Application WD/2023/2516/MAJ

1. We, the Steering Group of the Village Concerns Action Group, represent the views of over 200 supporters from our community and we object to Planning Application WD/2023/2516/MAJ.

Figure 1 - Transport Statement dated Oct 2023. Showing footpath on both sides of entrance.

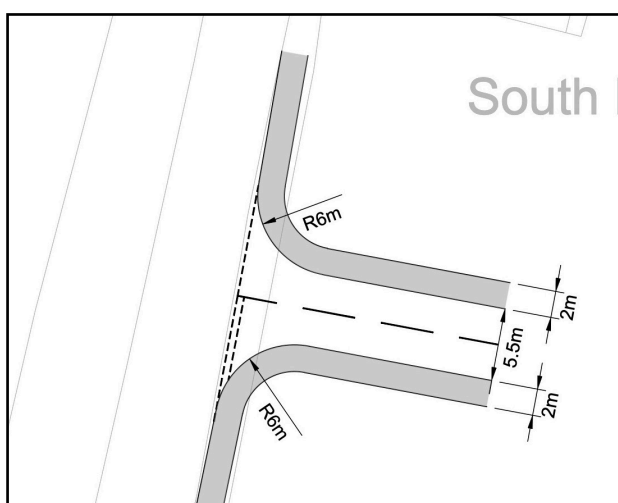
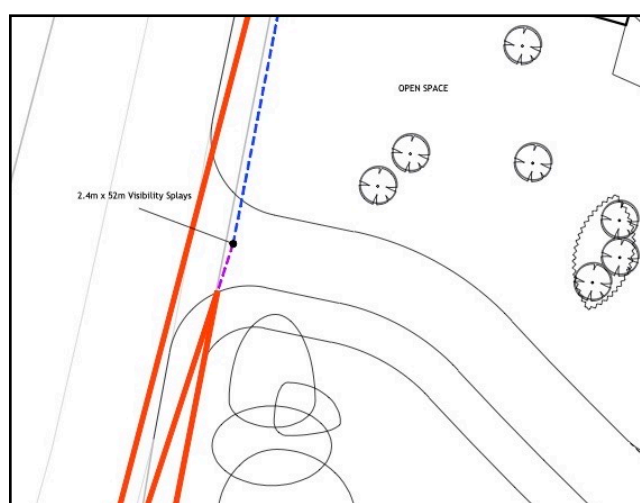
6. The WDC Conservation Officer stated that: “It would also be critical to retain the non-designated heritage asset that sits within the site and utilise the existing access onto the site rather than creating new access points”. There is no need for a new entrance to this site. One currently exists that is sufficient for 20 homes and this should be utilised. It would simplify the South Street access and improve safety. The proposed new entrance is shown in 2 conflicting forms at Figures 1 and 2:

Figure 5 - showing how the proposed buildings obscure the view of the Circle of Oak trees.

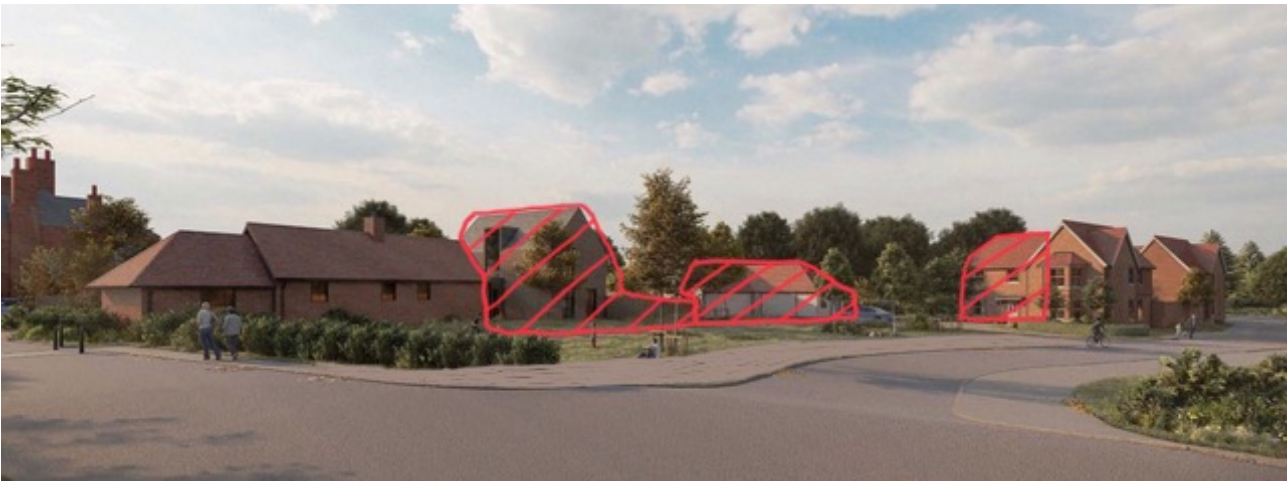
8. In both the images above, this does not represent a preservation of the rural edge of the village and the Conservation Area. The only way to comply with this would be to reduce the two storey extension to the stable block and the garage block so that the Circle of Oaks can be seen. The red marking on Figure 4 below shows how the view of the Circle of Oak trees is obscured. Also, the creation of an unnecessary road access and pavements ruins the rural aspect of this image. The inclusion of this unnecessary access will cause harm to the Setting of the Conservation Area, Park Lodge, Cherry Tree Cottages and the non-designated Heritage Asset on the site.

9. Plot 3 is not a solution to the conservation issue and will not address the harm to the Setting of the Conservation Area, Park Lodge, Cherry Tree Cottages and the non-designated Heritage Asset on the site. The Conservation Officer suggested: “the stables building should also be provided with a use to ensure its long term repair and maintenance and it was suggested that this could be converted to a single storey dwelling, perhaps with a small extension”. The applicants proposal is not for a small extension. It is a 3 bed home of two storeys which increases the floor area of the original building by 161%. A small extension might have been a one bedroom house with a one storey extension. Using the stables as a commercial space would be an alternative to bring some employment opportunities to the community or possibly a community building.

Figure 11 - Showing discharge of Surface Water from Circle of Oaks site onto South Street

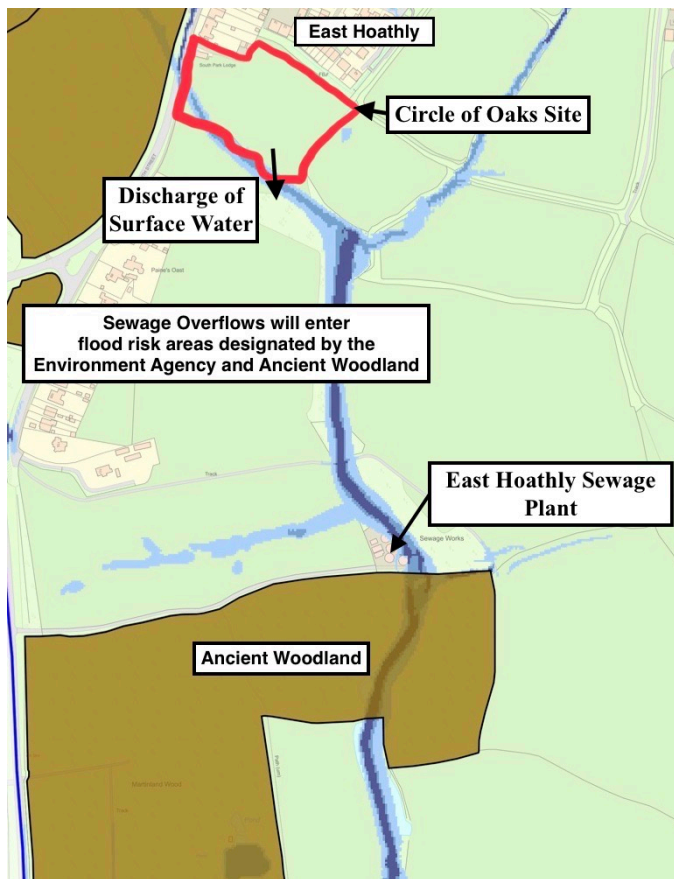
(3) The proposed development will collect all storm water from roofs and gutters and all surface water drainage into underground tanks which feed into an attenuation pond in the South East corner of the site. This will then discharge through a pipe onto the land that has been approved for development of 55 houses. This focussing of all the rain water into one discharge point will have an effect on the flood risk in the area of discharge and beyond. This has not been considered in the Flood Impact Assessment and there is no indication that the Applicant has liaised with the adjoining landowner. This has also not been considered in the Ecological Appraisal. This area is already known to be an area at risk of flooding:

Figure 12 - Applicant's plan showing route of sewer marked in yellow compared with Southern Water plan shown in red.

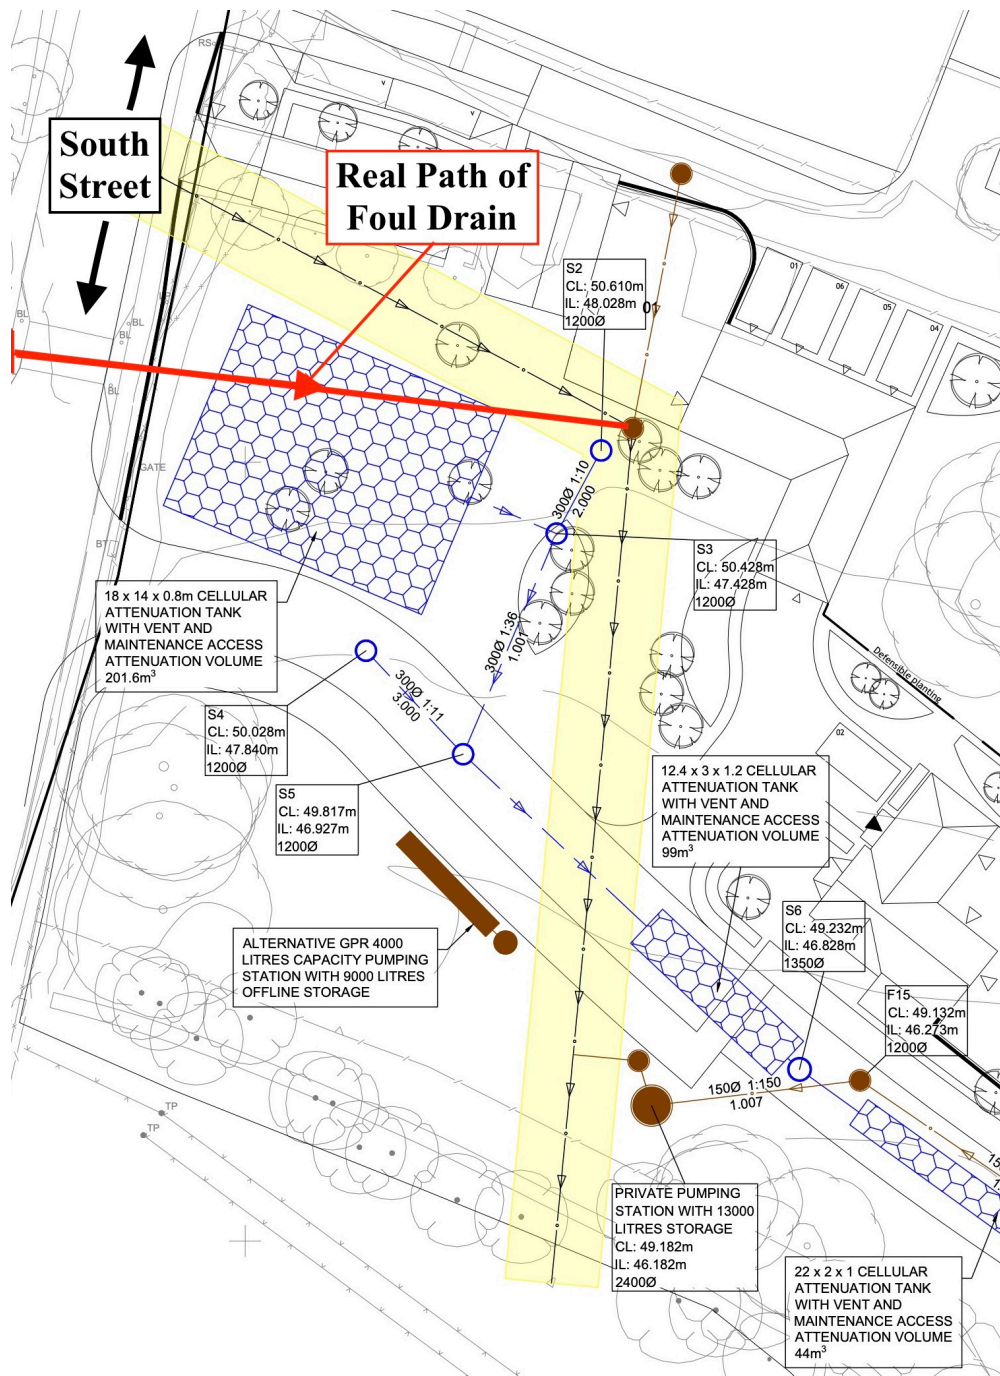
(4) The foul drainage plan is confused and not sufficient for a full planning application. Southern Water (Southern Water Reference DSA000022709 dated 19 May 2023) has apparently indicated that there is no capacity issue but there is no indication that this letter has taken into account the development on South Street or Hesmonds. The foul drain position on the site plans are incorrect when compared to the Southern Water plans. This would have an impact on the proposed underground storage tank shown on the drainage plan. On another document (WD-2023-2516-MAJ_Statements-Reports_TF1237-FAB-00-XX-RP-G-830, Appendix 3) the foul drain is shown in another position entirely and marked as “existing sewer diverted”. The proposed route takes the sewer underneath the attenuation pond. These plans are a mess and inadequate for a full planning application. There is no indication if the Applicant has liaised with the adjoining landowner regarding this proposed re-positioning of the sewer nor any liaison with Southern Water, nor the PC.

(b) Notwithstanding the incorrect and differing routes shown for the Southern Water sewer, the real route of the sewer fails to comply with the requirement for no construction within 3 metres of the sewer.

Figure 13 - Another route shown by Applicant for diversion of main East Hoathly sewer.

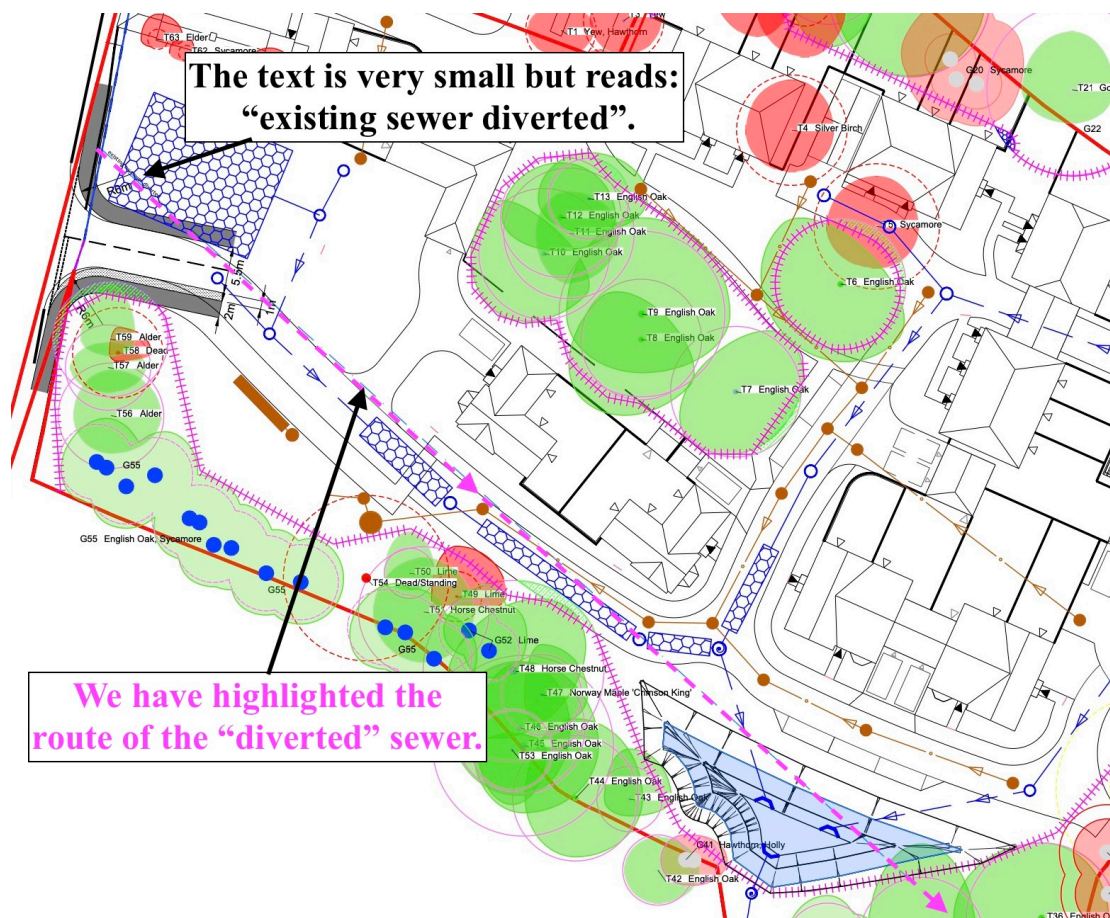
(c) The submitted drainage strategy shows a cellular attenuation tank within 5 metres of the sewer and this is not permitted (a second cellular attenuation tank is also within 5 metres of the sewer but Southern Water have not mentioned this).

Figure 20 - Space for Refuse Vehicle to Pass

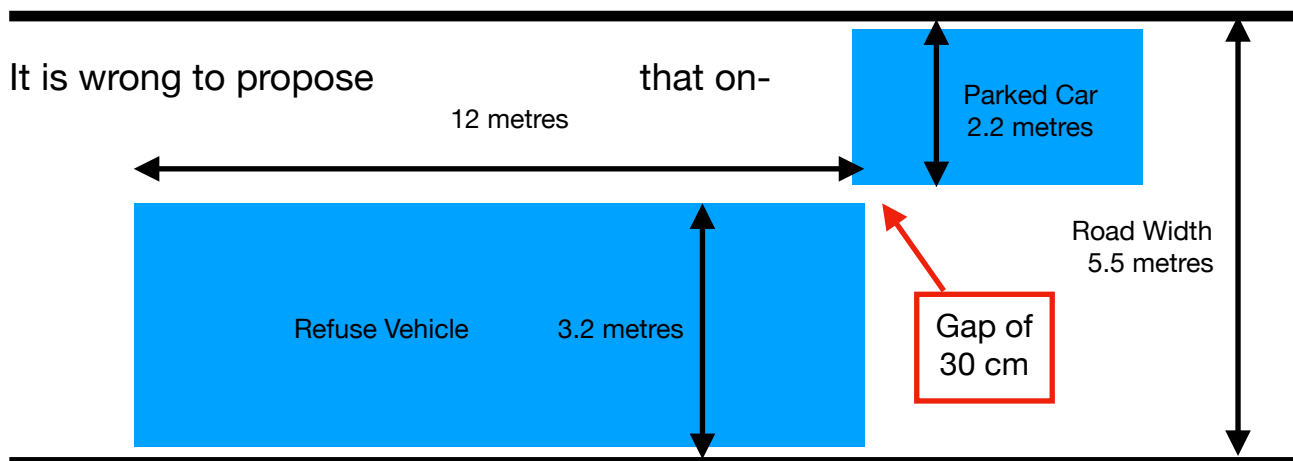
68. The Transport Statement states that the application is in outline - this is wrong, it is a full application. It states that: “ample visitor parking opportunities are available on-street along the 5.5m wide site access road”.

69. The average UK car width is 1.82 metres with the widest at 2 metres. Given that people will park at least 20 centimetres away from the kerb and a Refuse Vehicle should pass a parked vehicle with at least 20 centimetres clearance to the opposite kerb, this leaves a gap of only 30 centimetres in the centre of the road. This does not take account of curves in the roadway and the probability of multiple parked cars, larger vans or vehicles parked more than 20 centimetres from the kerb. Figure 20 shows how the Applicant's proposal for on-street parking is unworkable and will encourage vehicles to park on pavements or for refuse vehicles to mount pavements.
